March 22, 2019

Recommendations for wake loss calculation for offshore wind farms.

Status March 2019 by Per Nielsen, EMD International Ltd.

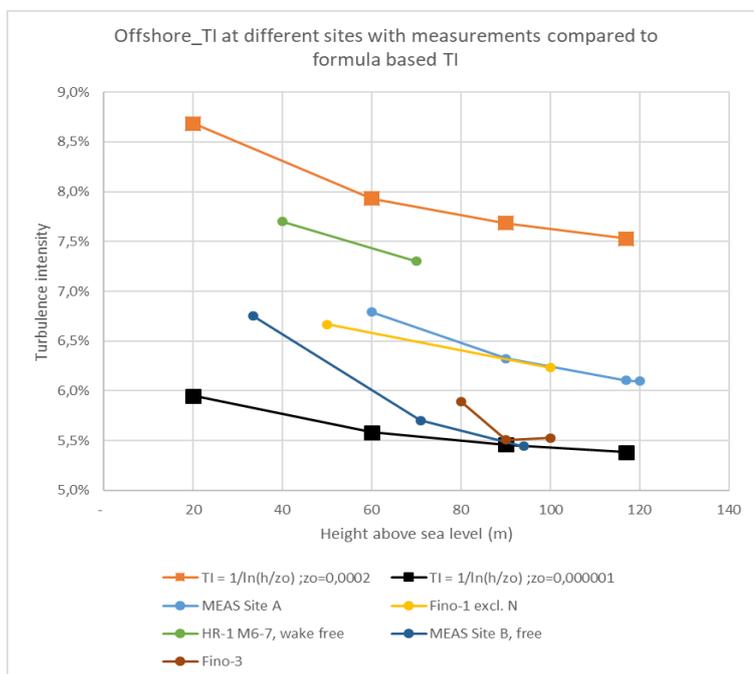
The EMD windPRO 3.2 recommendations do not comply well with several test cases offshore.

For PARK 2 is seen at HR-1 that WDC = TI x 0.8 do the job perfect. We thereby (also based on other offshore test sites) revise the offshore recommendations so 0.8 replaces 0.48 for PARK-2, and the 20% lower PARK-1 values thereby changes the factor on TI from 0.4 to 0.67, see example tables below.

PARK-1	PARK-2
High TI	TI:	7,50%
Factor	0,67	0,8
WDC	0,050	0,060

PARK-1	PARK-2
Low TI	TI:	6,00%
Factor	0,67	0,8
WDC	0,040	0,048
